UNITED STATES PATENT AND TRADEMARK OFFICE

APPLICATION NO.	FILING DATE	FIRST NAMED INVENTOR	ATTORNEY DOCKET NO.	CONFIRMATION NO.
09/516,753	03/01/2000	Gregory Pinchasik	2390/49701	3706
27123	7590	03/15/2005	EXAMINER	
MORGAN & FINNEGAN, L.L.P. 3 WORLD FINANCIAL CENTER NEW YORK, NY 10281-2101			BUI, VY Q	
			ART UNIT	PAPER NUMBER
			3731

Office Action Summary

DETAILED ACTION

Von Oepen-'634 (Fig. 10 as presented on page 3) discloses substantially all limitations as recited in the claims.

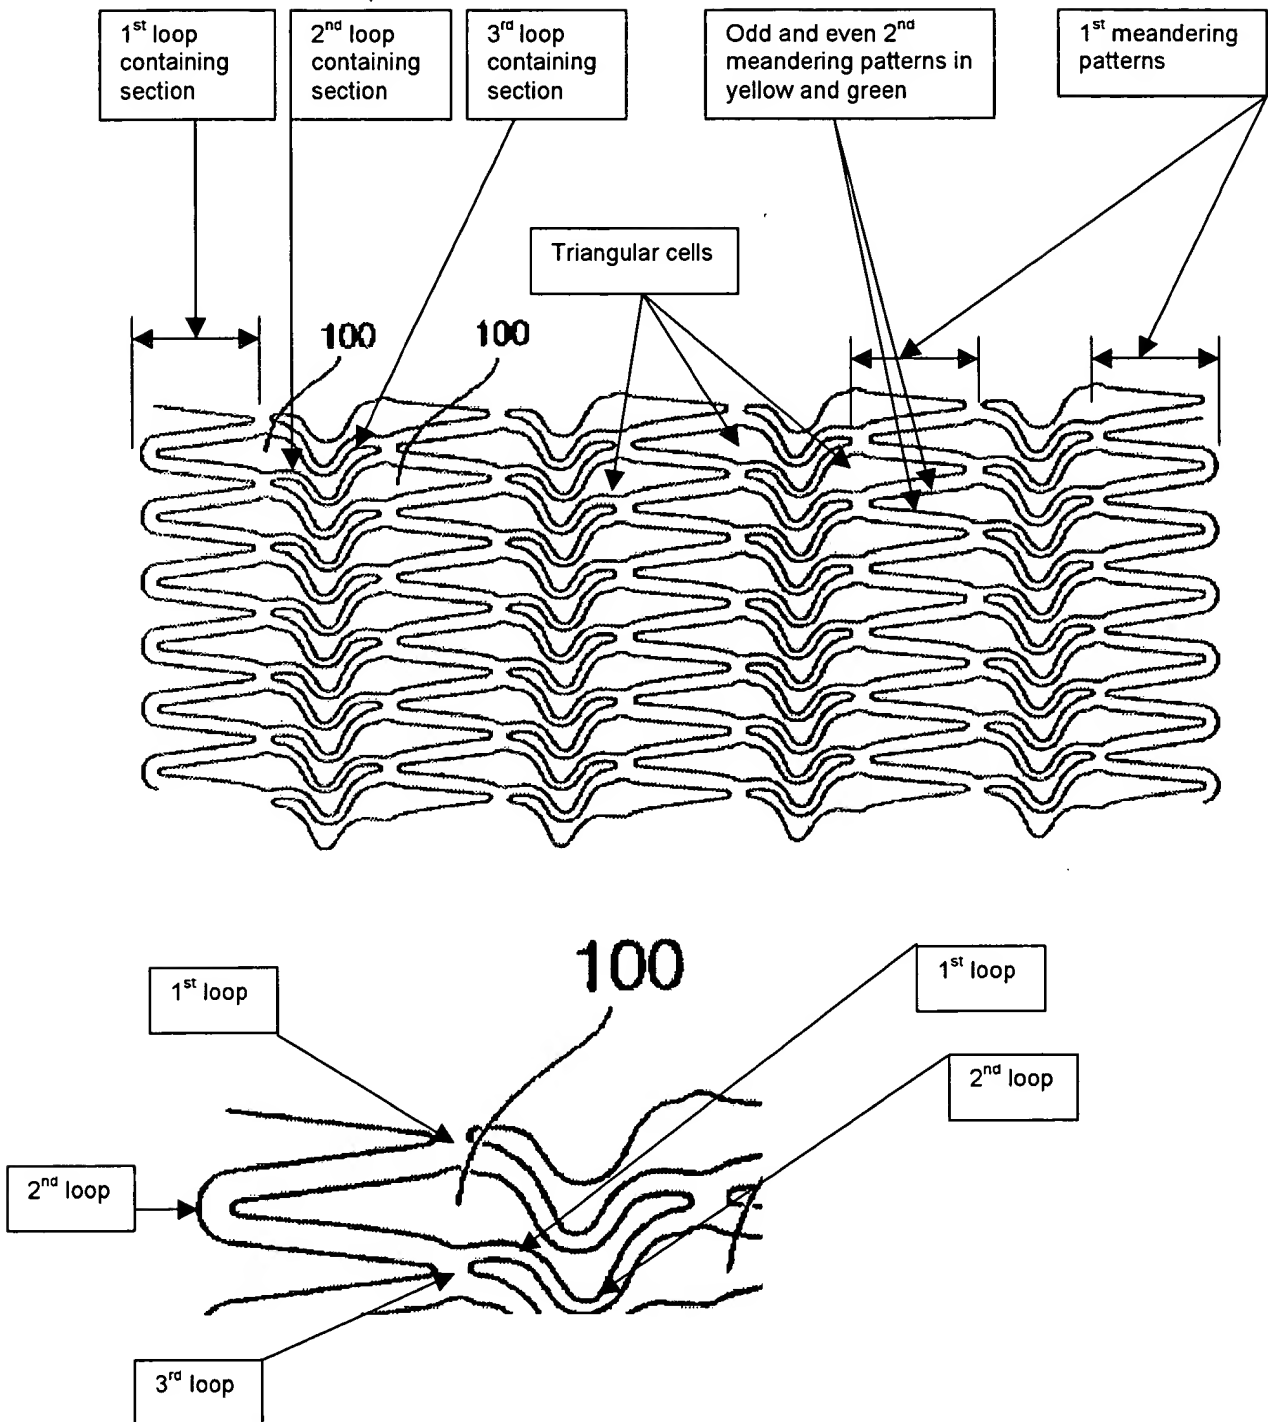
1. Claims 1-6, 9-11, 21, 23-25, 28-33, 35 are rejected under 35 U.S.C. 102(b) as being anticipated by Von Oepen-WO 98/35634.

As to claims 95-102, 104-105, 108-111, 113-114, 116-119, 122 and 125, Brown-'793 (Fig. 2, reproduced and shown on next page) discloses substantially all limitations as recited in the claims, except for the 1st loop containing section has wider legs than the 2nd and 3rd loop containing sections.

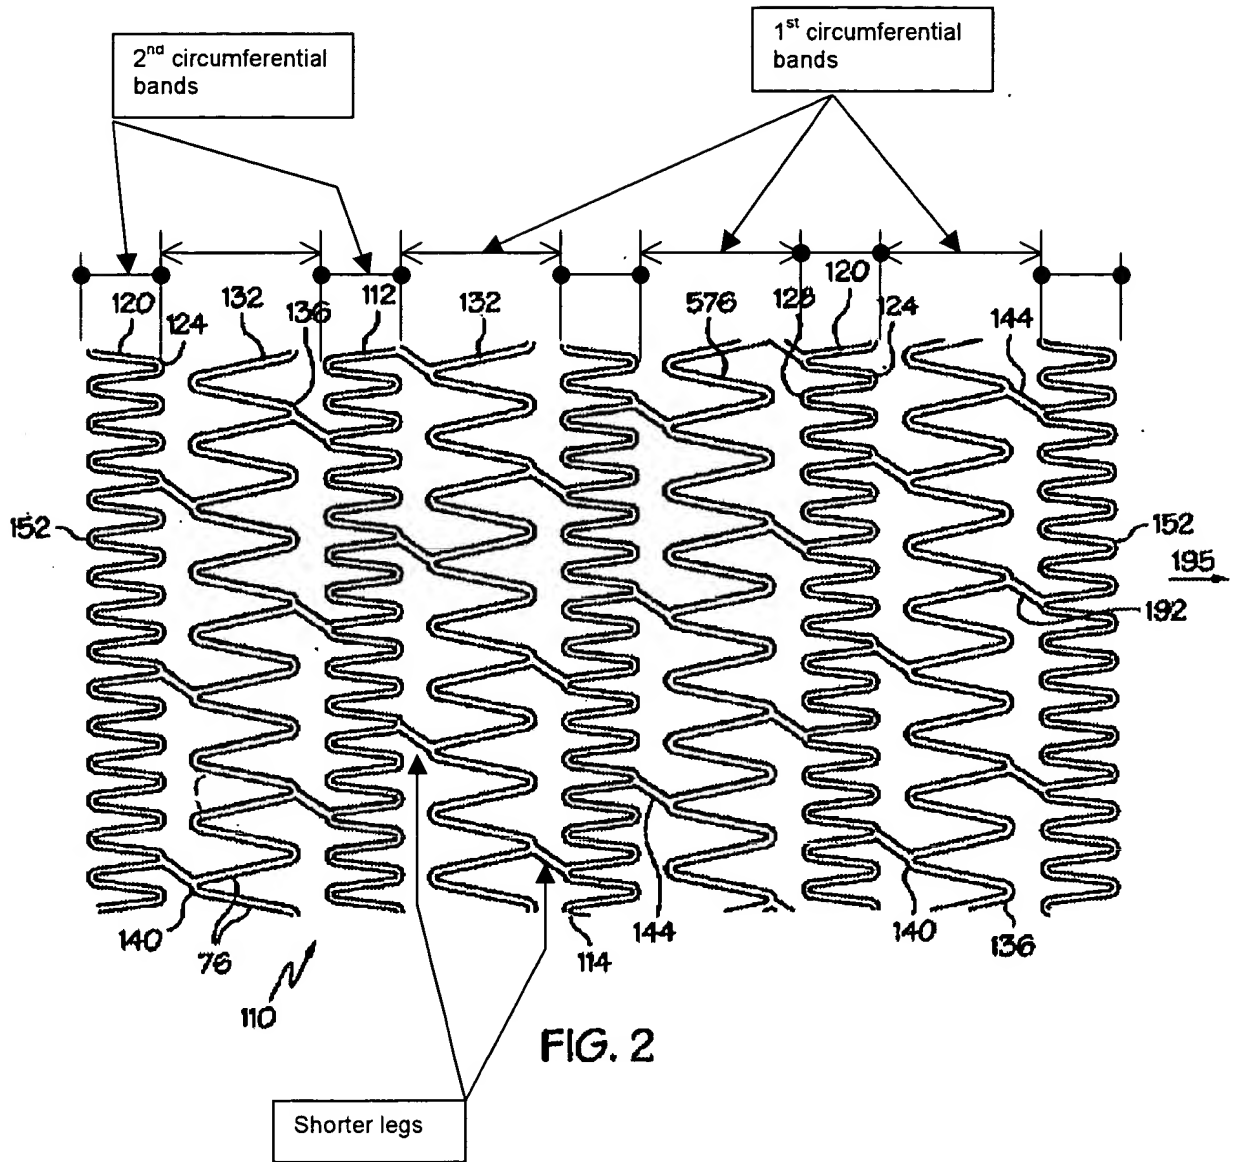
2. Claims 95-100, 104-105, 108-111, 113-114, 116-119, 122, 125 are rejected under 35 U.S.C. 103(a) as being unpatentable over Brown et al-6,776,793 in view of Von Oepen-WO 98/35634.

However, it is well known in the art to have a stent with bands having wider legs alternating with bands having narrow legs to provide flexibility for the stent. For example, Von Oepen (Fig. 10) above shows bands of 1st loop containing section having wider legs and bands of 2nd and 3rd loop containing sections having narrower legs to enhance flexibility of the stent. In view of Von Oepen, it would have been obvious to one of ordinary skill in the art at the time of the invention to make bands of 1st loop containing sections of Brown stent to have legs wider than legs of bands formed of 2nd and 3rd loop containing sections so that Brown stent would be more flexible to adapt itself to a blood vessel. Notice that Brown's Fig. 2 shows 1st circumferential bands having a basically sinusoidal pattern of loops at a 1st frequency and 2nd circumferential bands having a basically sinusoidal pattern of loops at a 2nd frequency higher than the 1st frequency as recited in the claims.
